SUBJECT: **Addendum No. 2**
Diamond Springs Parkway – Phase 1A – SR- 49 Realignment Project, Contract No. 2720, CIP No. 72375

**to the contract documents for
Diamond Springs Parkway – Phase 1A – SR-49 Realignment
CIP No. 72375, Contract No. 2720**

SR-49 REALIGNMENT -
DIAMOND SPRINGS PARKWAY
PHASE 1A

STOCKPILE LOCATIONS

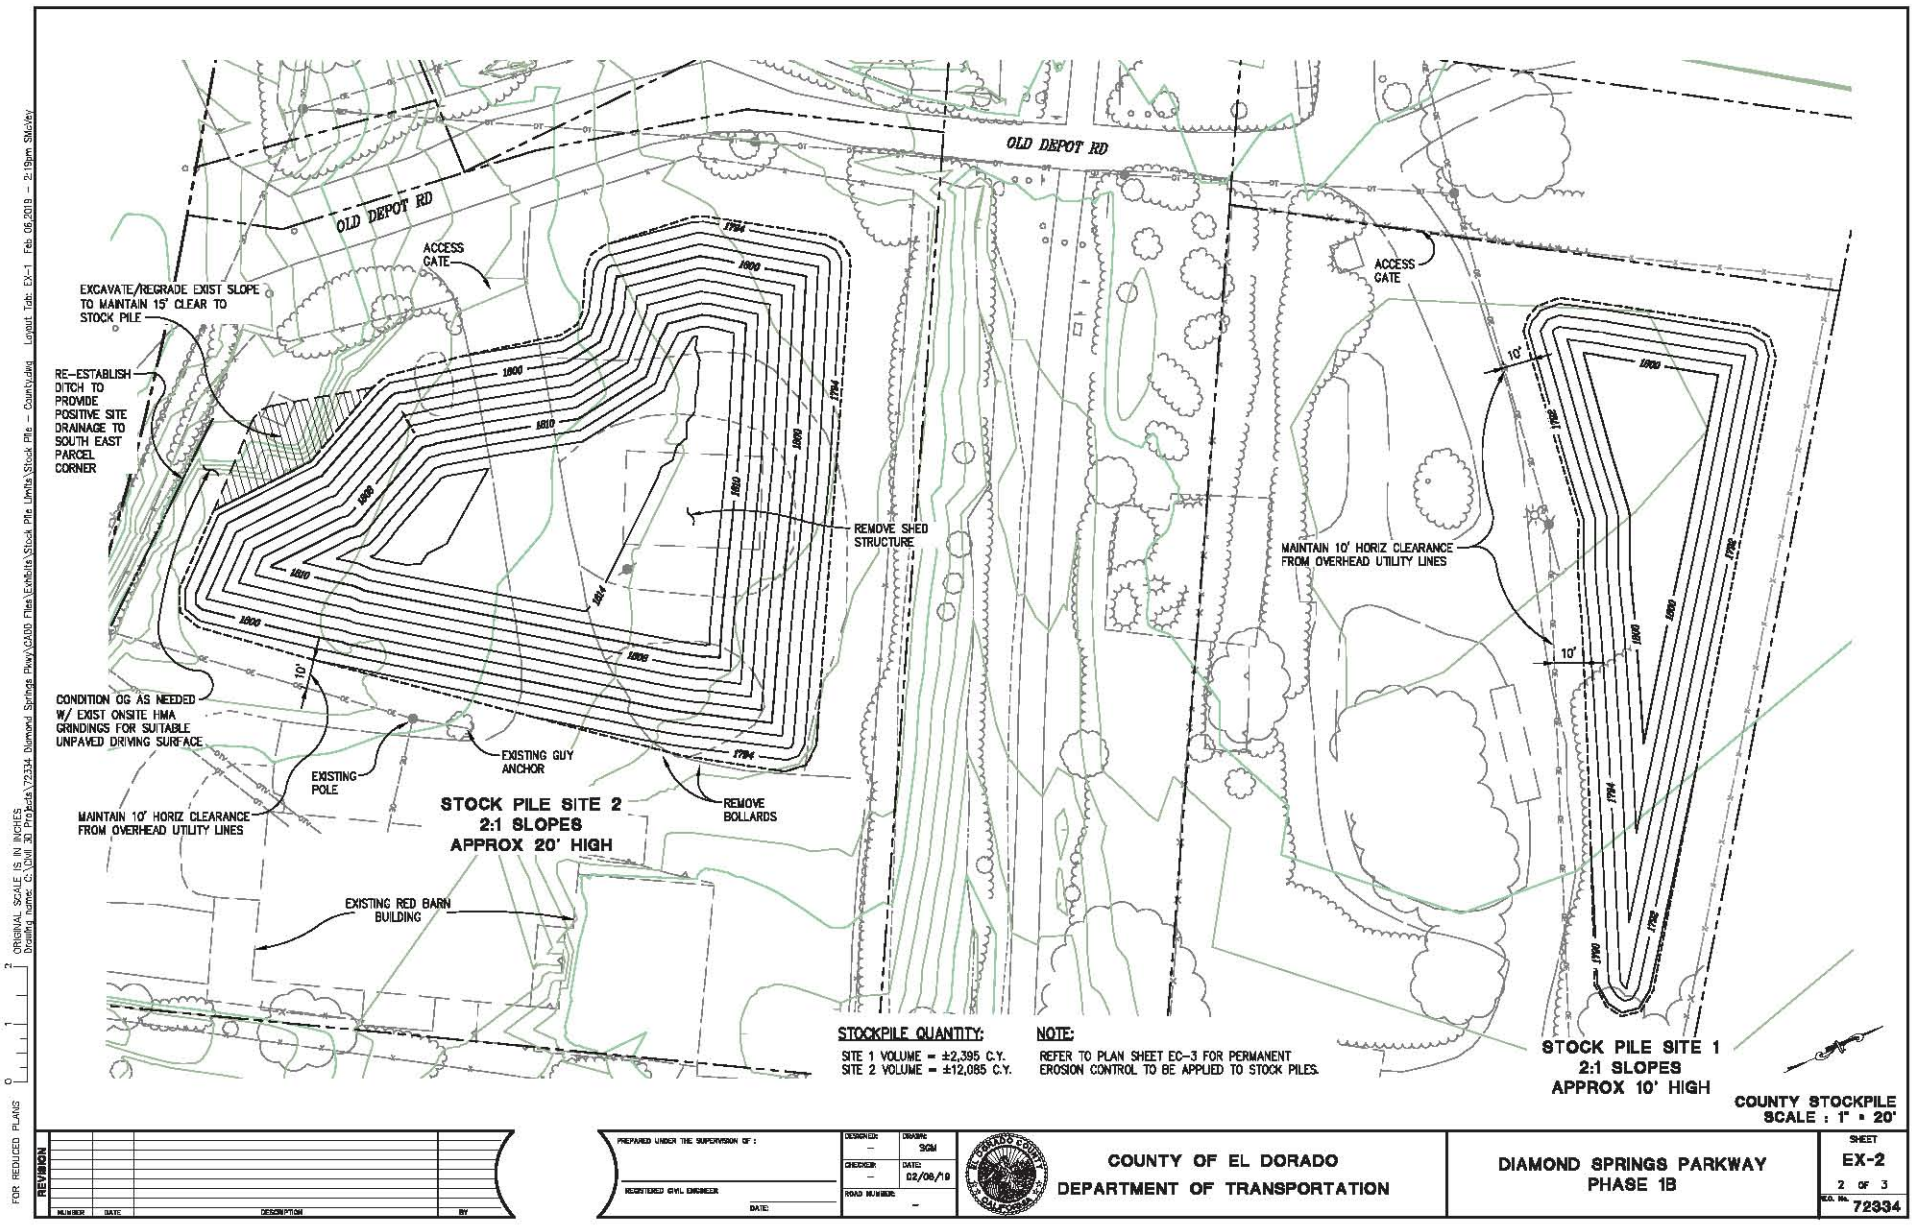
2.12	Appendix D	Bidders are instructed to replace Appendix D, “Stockpile Locations” with the attached revised Appendix D, “Stockpile Locations” to the Special Provisions:

2.03	SP-42	Bidders are Instructed to add the following to section 13 of the Special Provisions: <div style="text-align: center;">Add to section 13-4.03C(3):</div> <p style="text-align: center;">For location of roadway excavation stockpiles see Appendix D.</p>

2.05	SP-50	<p>Bidders are Instructed to add the following to section 17 of the Special Provisions:</p> <p style="text-align: center;">Add to section 17-2.03A:</p> <p>Clear and grub Department-owned property as necessary in order to construct the stockpiles shown in Appendix D.</p>

2.08	SP-51	<p>Bidders are Instructed to add the following to section 19 of the Special Provisions:</p> <p style="text-align: center;">Add to 2nd paragraph in section 19-2.04:</p> <p>4. Stockpiling roadway excavation material in stockpile locations shown in Appendix D.</p>

SHEET
EC-3
71 OF 95
W.O. No. 72375

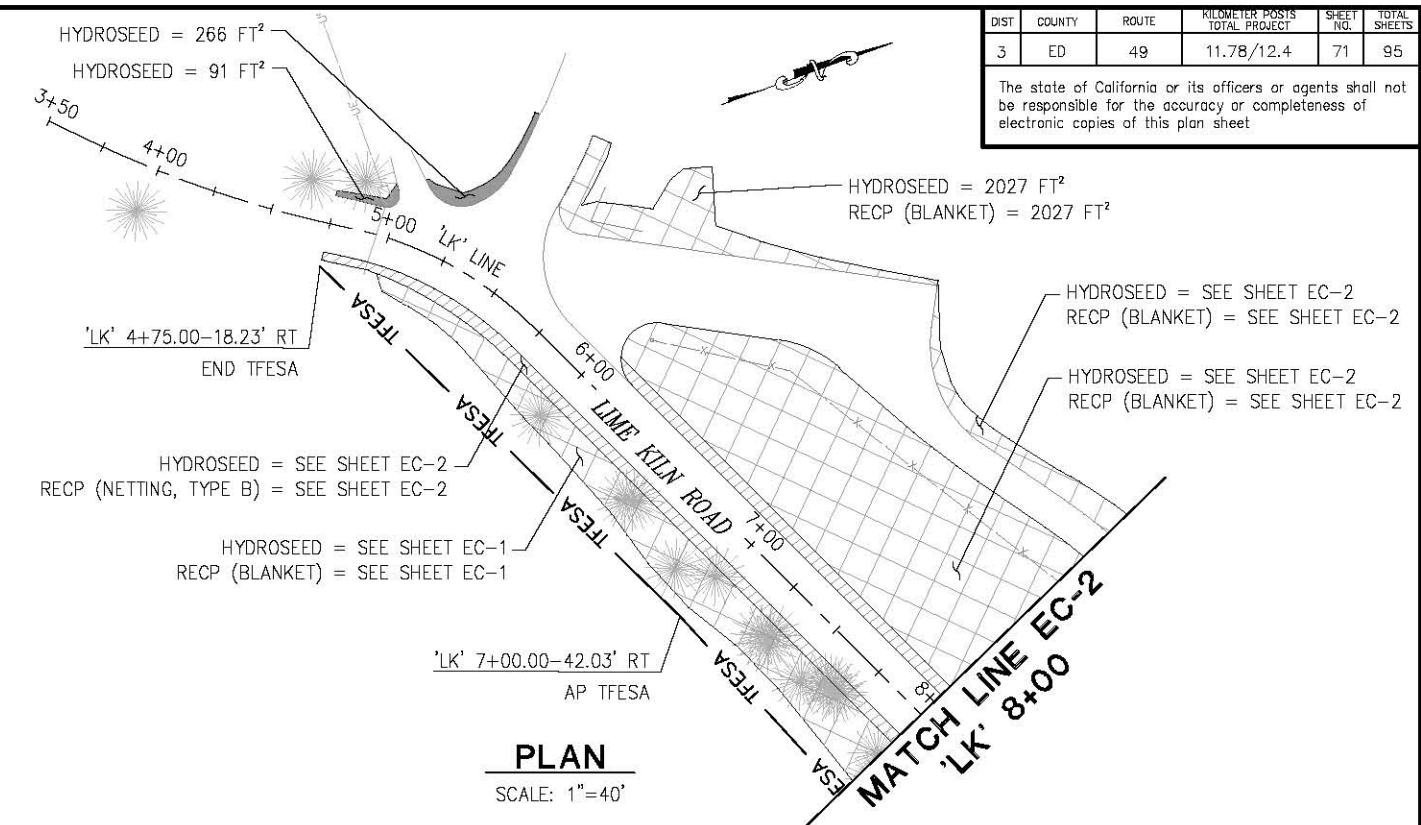
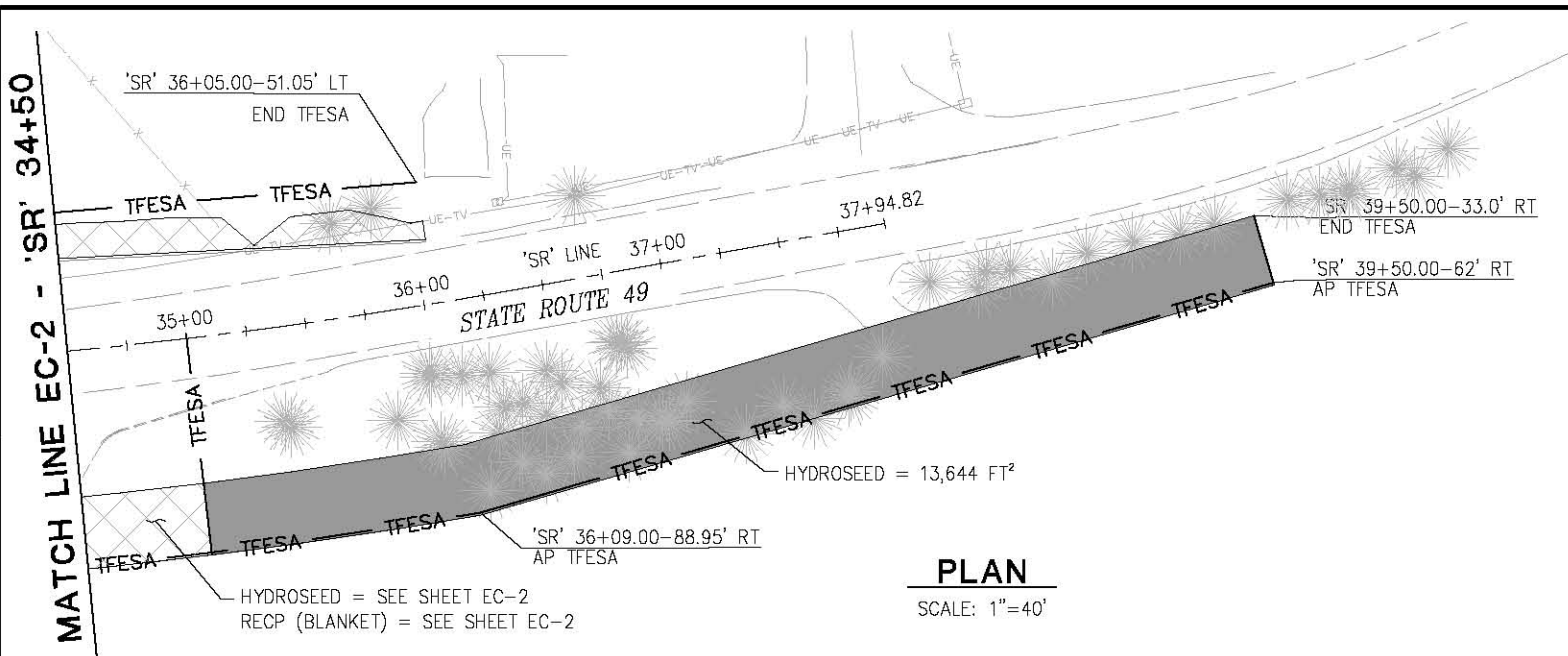
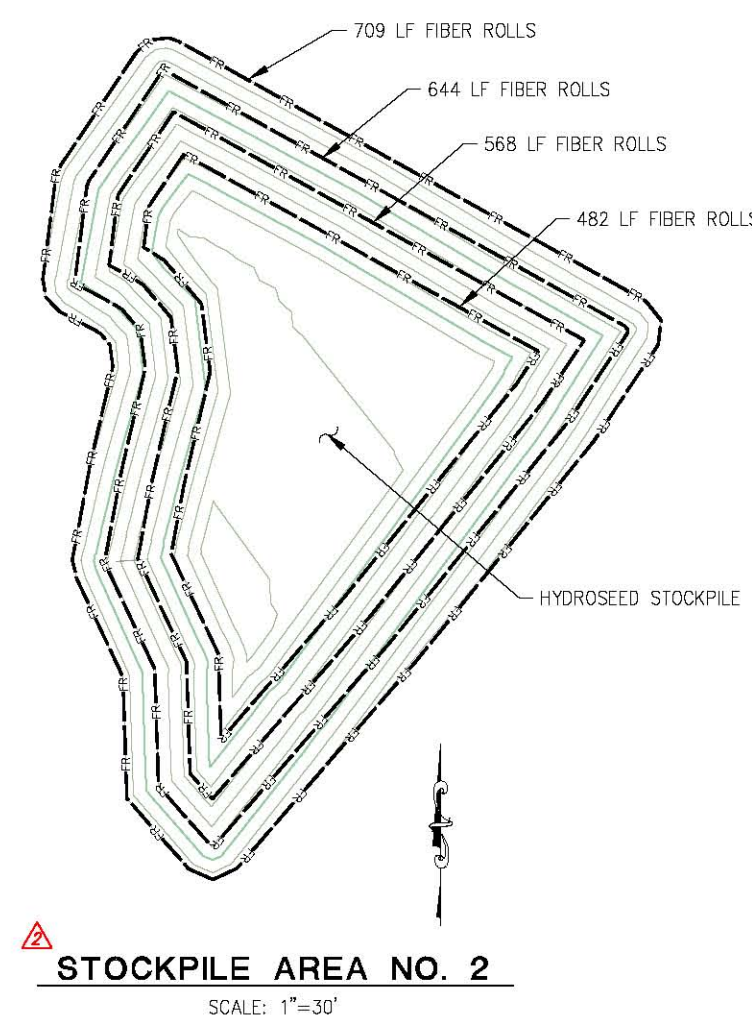
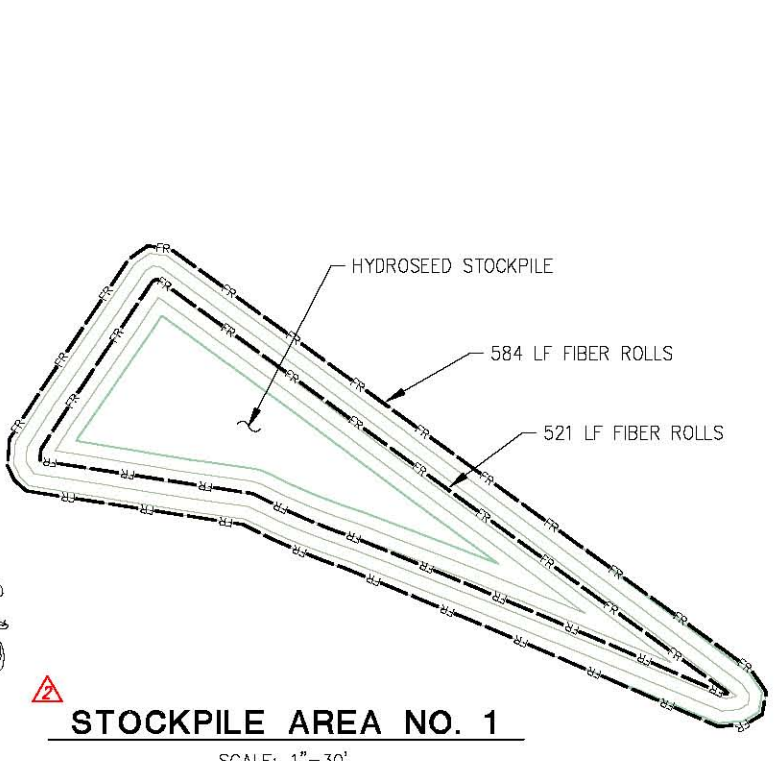
2.15	Plan Sheet EC-3	Bidders are instructed to replace Plan Sheet EC-3, “EID Waterline Plan” with the attached revised Plan Sheet W-5.
2.16	Plan Sheet W-5	Bidders are instructed to replace Plan Sheet W-5, “EID Waterline Plan” with the attached revised Plan Sheet W-5.

REVISION	NUMBER	DATE	DESCRIPTION	BY
	1	02/06/19	ADDENDUM #2 - STOCKPILES ADDED	DWH
